# UNITED STATES PATENT AND TRADEMARK OFFICE

APPLICATION NO.	FILING DATE	FIRST NAMED INVENTOR	ATTORNEY DOCKET NO.	CONFIRMATION NO.
10/042,829	01/08/2002	Chi Wah Cheng	P/4076-10	7316
2352	7590	11/19/2003	EXAMINER	
OSTROLENK FABER GERB & SOFFEN 1180 AVENUE OF THE AMERICAS NEW YORK, NY 100368403			STONER, KILEY SHAWN	
			ART UNIT	PAPER NUMBER
			1725

<b>Office Action Summary</b>	<b>Application No.</b> 10/042,829	<b>Applicant(s)</b> CHENG ET AL.	
	<b>Examiner</b> Kiley Stoner	<b>Art Unit</b> 1725

## **DETAILED ACTION**

**FIG. 4**

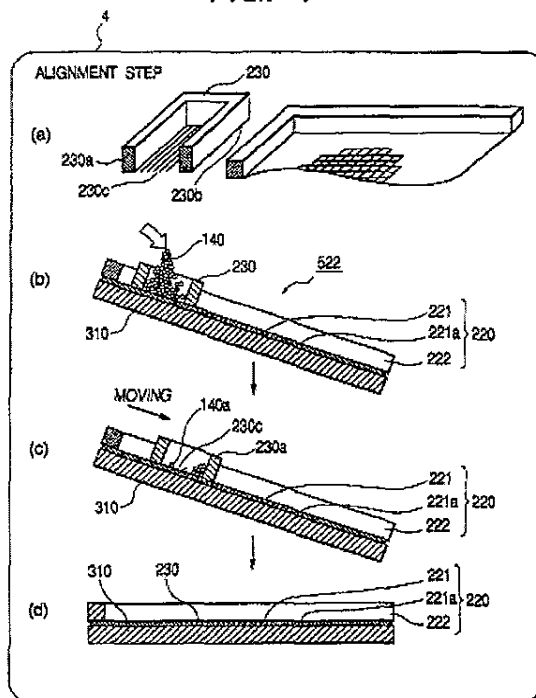
In Figure 4, Ooroku et al. teaches tilting means adapted to rotate the container about an axis perpendicular to the direction of motion of the container to thereby tilt it. The mechanism used to tilt the container of Ooroku et al. is capable of rotating the container and the positioning means a plurality of times when the container is in position directly over the positioning means.

**FIG. 5**

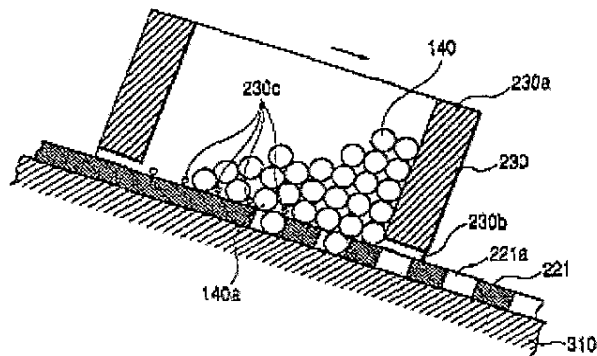
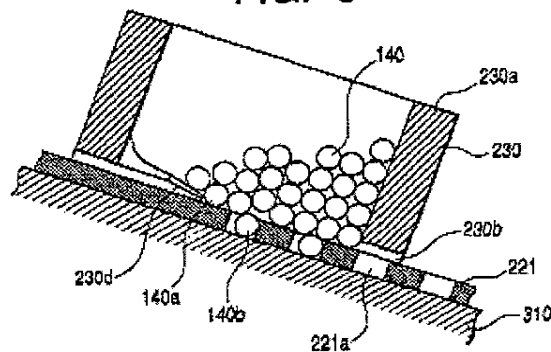
In addition Ooroku et al. teaches the rotational angles of the container and/or the moving speed of the container are controllable to optimize efficiency (column 9, lines 33-38 and column 10, lines 47-65); and the plurality of apertures are located substantially toward one end of the positioning member whereby the container is in communication with the apertures on the positioning member only while the container is in the vicinity of the second position (Figures 5-6).

**FIG. 9**

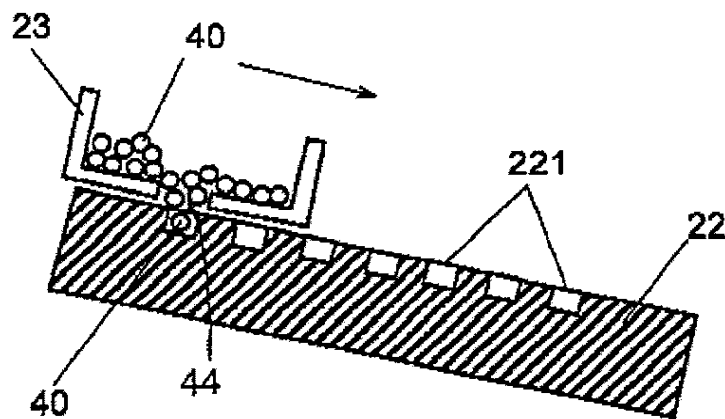
Kasai et al. teaches a guide member which is configured to direct the solder balls to positions corresponding to the array of positions the solder balls are to take up on the substrate (Figure 9, specifically #22); a container for a plurality of solder balls, the container being movable between a first position remote from the guide member and a

second positioned directly in communication with the guide member (Figure 9, specifically #23); a mechanism configured to apply a force to the solder balls in the container in the direction of movement of the container as the container moves between the first position to the second position (Figure 9). On page 4, lines 5-9 and page 7, lines 1-19 of the specification the applicant uses a gravitational force and the force generated by the walls of the container during movement to bias the solder balls in the direction of movement of the container. The mechanism that Kasai et al. uses to move the container #23 applies force to the solder balls through both gravity and the side walls of the container #23. Figure 9 also teaches tilting means adapted to rotate the container about an axis perpendicular to the direction of motion of the container to thereby tilt it. The mechanism used to tilt the container of Kasai et al. is capable of rotating the container and the positioning means a plurality of times when the container is in position directly over the positioning means; In addition Kasai et al. teaches the rotational angles of the container and/or the moving speed of the container are controllable to optimize efficiency (column 5, lines 35-46); a positioning rail and motor whereby the motion of the container is guided and driven (column 4, lines 3-9 and column 5, lines 35-46); a vibration-generating device to facilitate the separation of solder balls from surfaces they are in contact with and/or from one another (column 5, lines 21-27); the positioning means includes a ball template with a plurality of apertures each slightly larger than the size of a solder ball in order to capture solder balls within the template, and wherein the plurality of apertures are arranged in an order similar to the array positions comprising solder pads on the substrate; solder balls captured in the

plurality of apertures are removable by a pick-and-place device while retaining their respective positions, and places onto corresponding positions of solder pads on the substrate; means to rotate the container, ball template and substrate simultaneously; the apertures comprises through-holes which allow solder balls to fall through the ball template directly onto a substrate placed below it (Figures 6A-B and 9).
